**Re: Lot 1 Block 2 Unit 18 Volcano Cliffs, S.A.D. 228
6616 Petirrojo NW
Request Permanent C.O. – Accepted
Engineer's Stamp dated: 2-19-18 (D10D003G1)
Certification dated: 10/26/18**

**Re: Lot 1 Block 2 Unit 18 Volcano Cliffs, S.A.D. 228
6616 Petirrojo NW
Request for Permanent C.O. – Not Accepted
Engineer's Stamp dated: 2-19-18 (D10D003G1)
Certification dated: 10/23/18**

CITY OF ALBUQUERQUE, BERNALILLO COUNTY		NEW MEXICO	
LOT 1, BLOCK 2, UNIT 18 VOLCANO CLIFFS SUBDIVISION			
SOUMPHOLPHAKDY - 6616 PETIRROJO - GRADING & DRAINAGE PLAN			
McDowell Engineering, Inc.			
7820 BEVERLY HILLS AVE. NE • ALBUQUERQUE, NM 87122			
TELE: 505-828-2430 • FAX: 505-821-4857			
Designed JSM	Drawn STAFF	Checked JSM	Sheet of
File SOU0118L	Date FEBRUARY, 2018		1 1

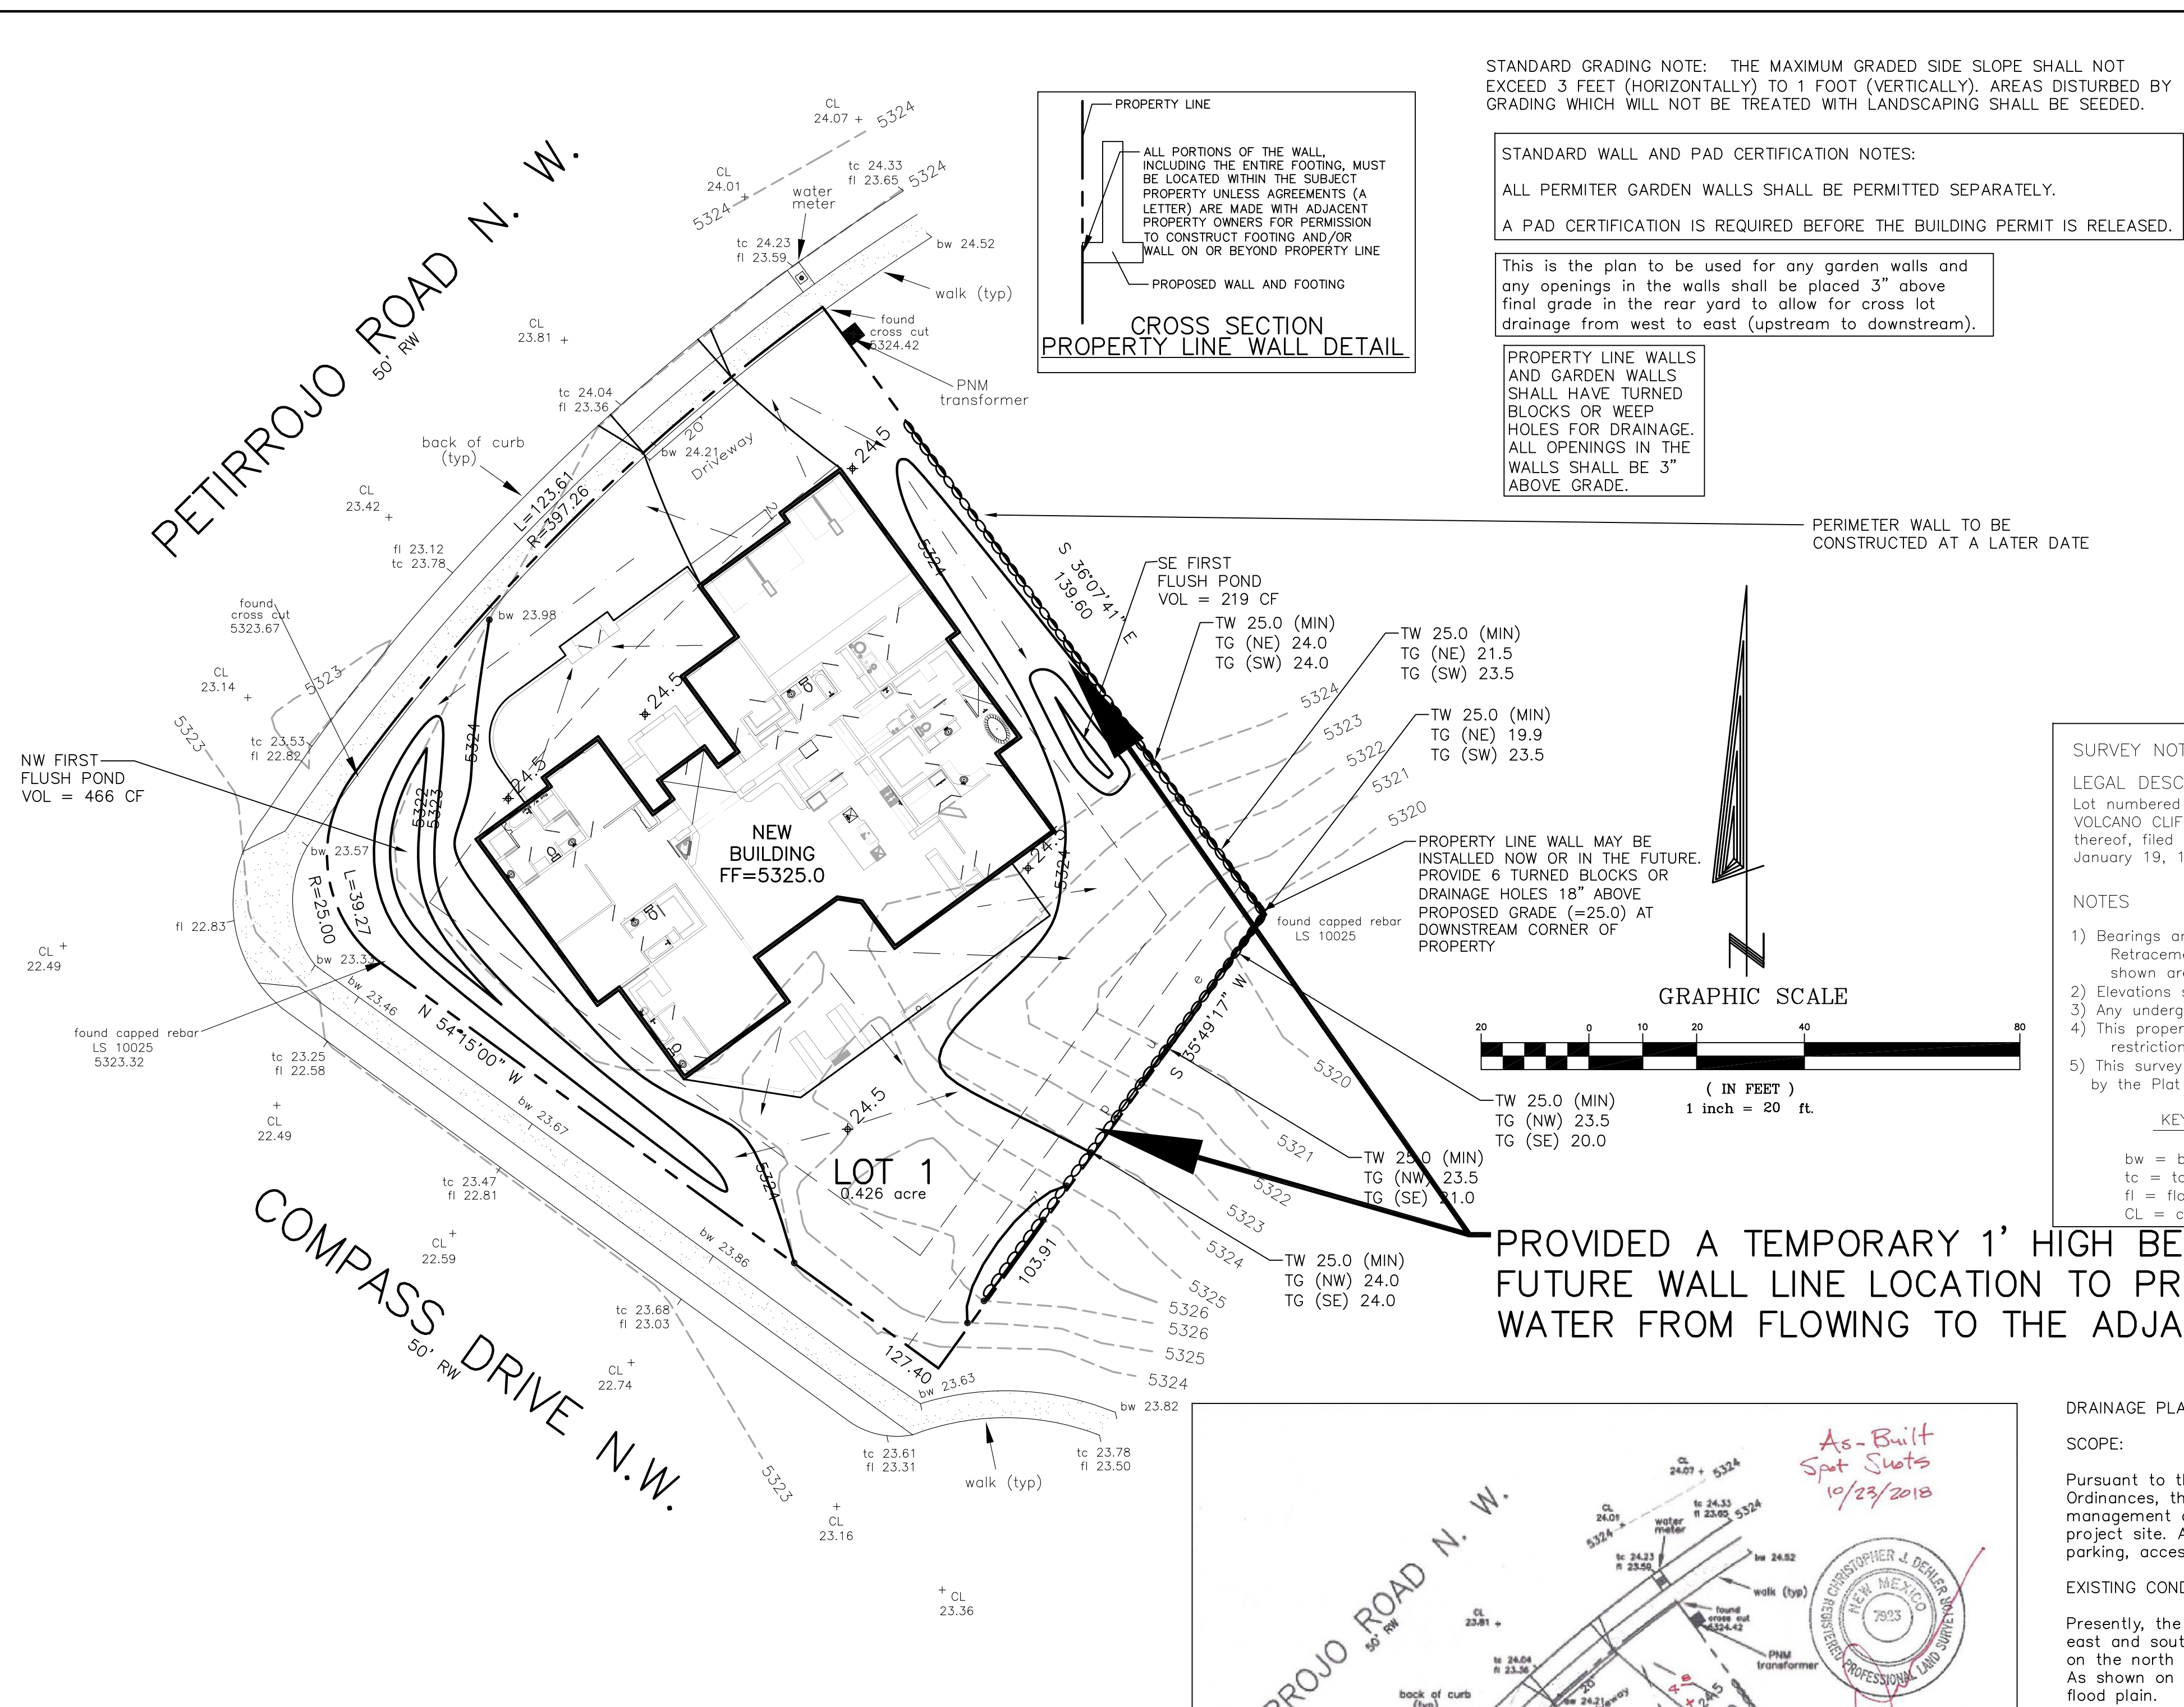
Based on the Certification received 10/23/18, this site cannot be accepted for release of Certificate of Occupancy by Hydrology until the following comments are addressed.

- Remove dirt from used as a ramp in street and sidewalk. **Done.**
- Provide how the raised lot will be protected from erosion on the North and west sides of the property line. **Landscaping will be provided at these locations to prevent erosion**
- Prevent the flows from entering Compass Dr. at the S.E. corner of the lot. All flows must enter the retention pond before flowing out into the public right of way. **Berm installed**
- Remove the debris pile and the container from the lot to the north.
Debris has been removed and container will be removed after the CO is issued.

All these items have been discussed with the owner and grading contractor, Will, and Rudy Rael and all items have been satisfied via email distributions.
